RE: Violation – Unpermitted Fill Removal  
Ag Exempt Building Uses – Oregon Building Codes  
Township 8, Range 9, Section 27, Tax Lot 1200, 1203  
92689 Walluski Loop Rd., Astoria, OR  
Agriculture Forestry Zone (AF)/Flood Hazard Overlay Zone (FHO)

Re: Notice of Violation, Michael & Laura Sarin

Re: OSS: NWR: Clatsop County: Site Evaluation Report: Twn 8N, Rng 9W, Section 27, Tax Lot  
1200: 5.15 Acres

Robert E. Harn Prop.  
 T.8N.,R.9W.,Sec.27 TL 1200  
 5.15 acres  
 Walluskie Loop Rd.  
 CLATSOP COUNTY

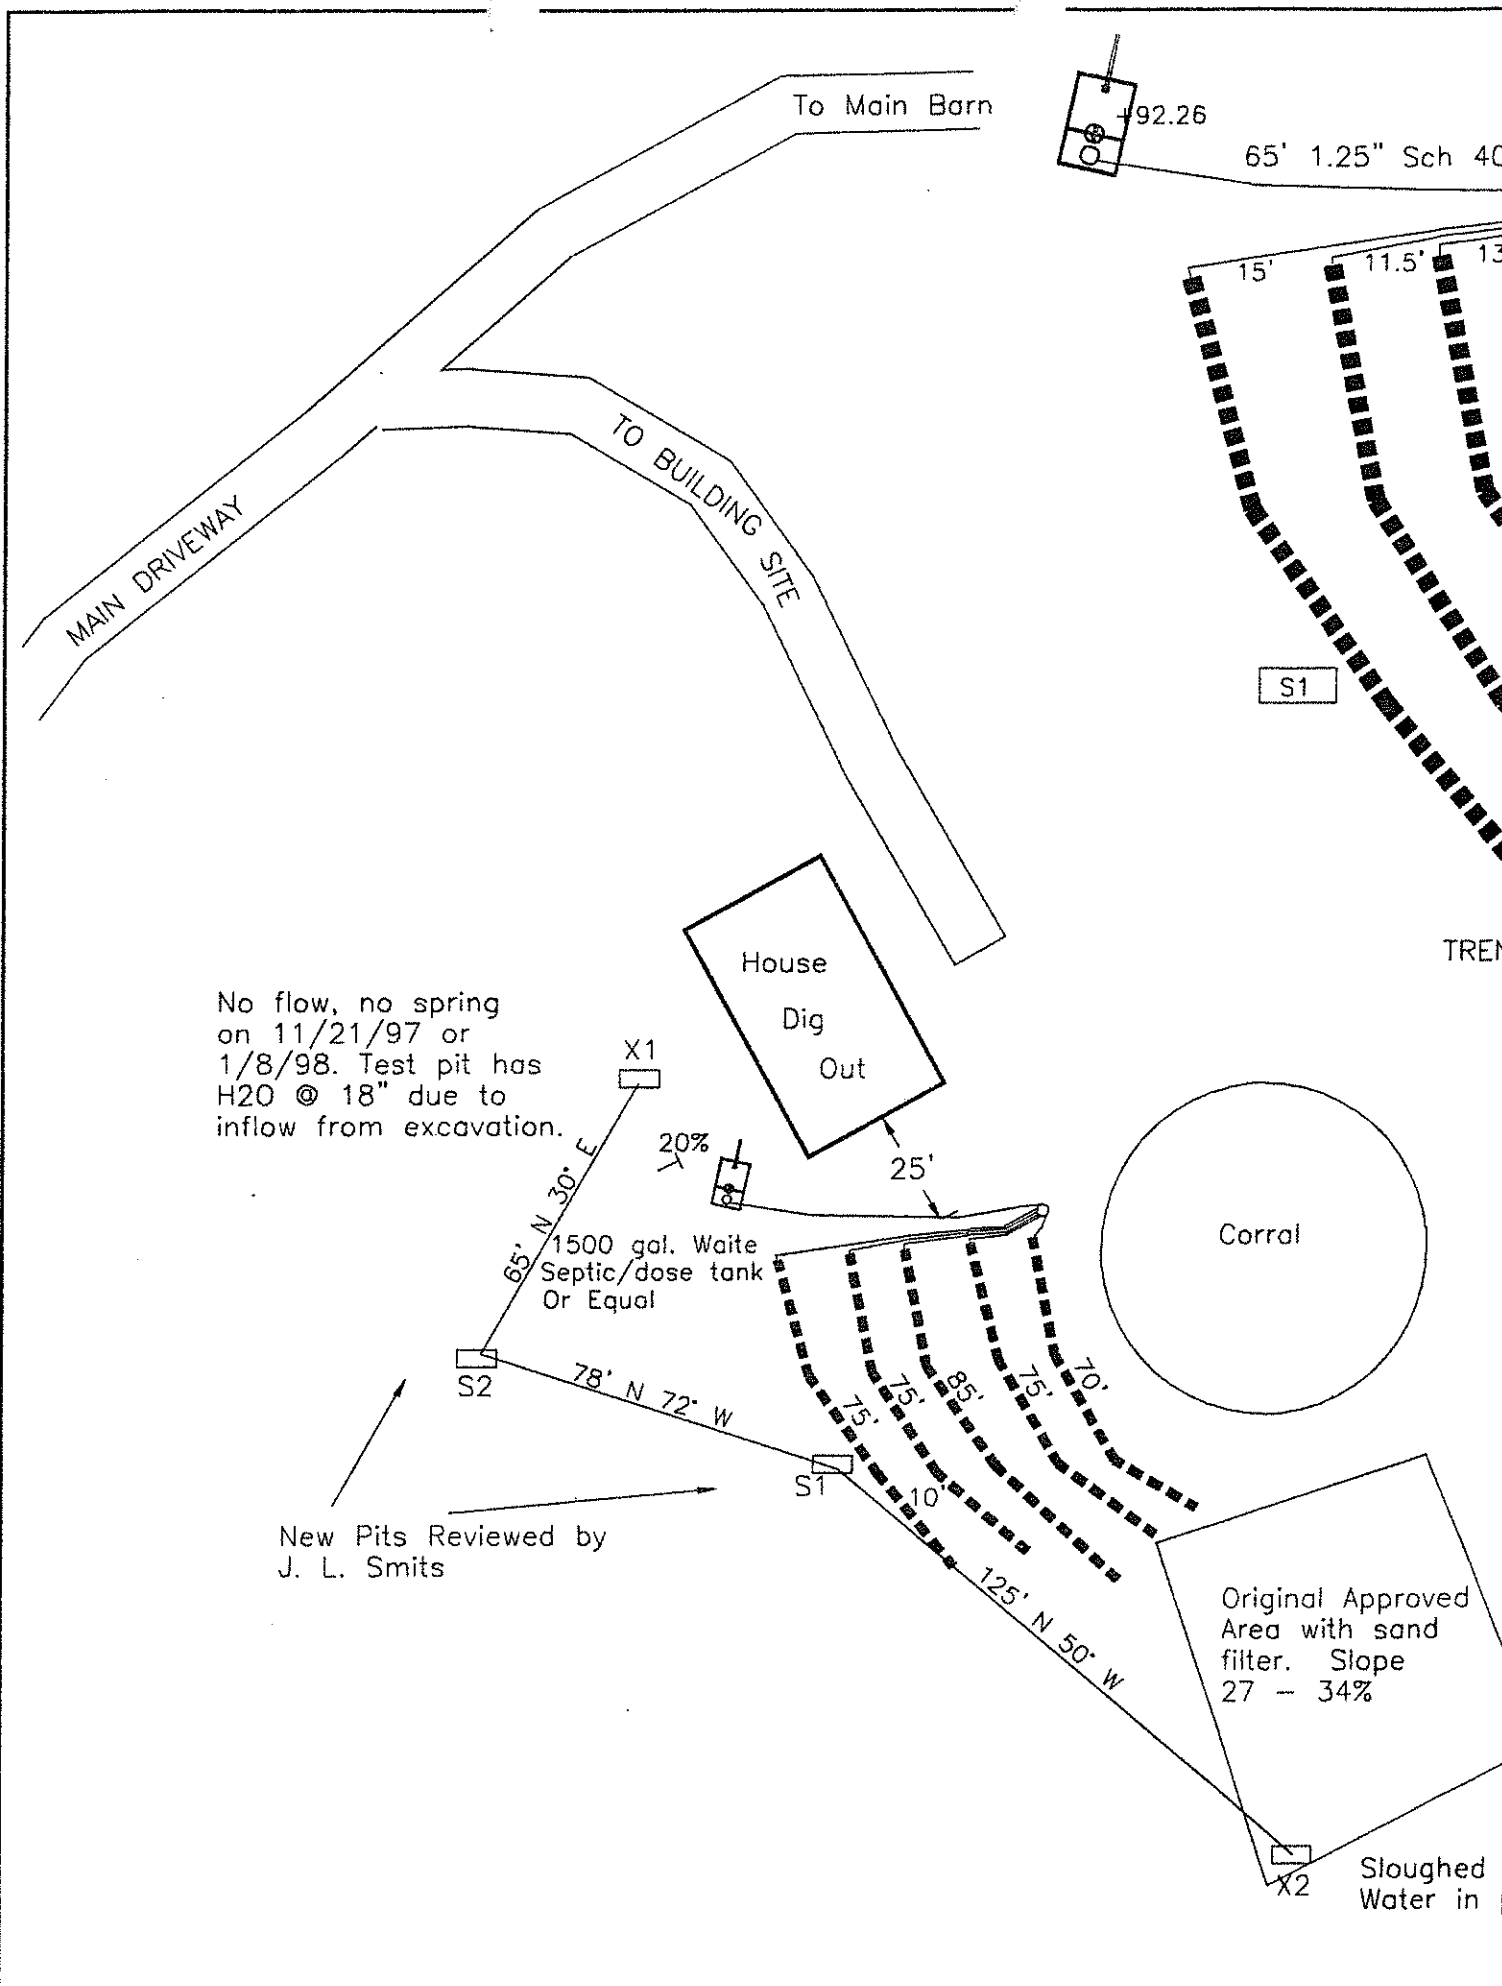
**PLEASE NOTE:** A surface water drainage channel has been cut through the area between the north ends of the drainfield and the proposed home site. It is imperative this surface water be captured and directed away from the drainfield area.

The drainfield must maintain a minimum 100 foot setback to any downgradient springs and wells, a 25 foot setback to any cutbanks, and a minimum 10 foot setback to water lines and underground utilities..

Please refer to Smits & Associates, Inc., plans and specifications dated February 3, 1998, for location of the disposal system (including the future repair/replacement disposal system). **The system will consist of a minimum 1,100 gallon dosing septic tank or equivalent, an effluent lift pump, associated controls and alarm, and 375 linear feet of disposal trench designed in equal distribution via a hydrosplitter. Trench depth will be 30 to 36 inches. The replacement system when necessary in the future, will consist of an alternative conventional sand filter treatment and disposal system.**
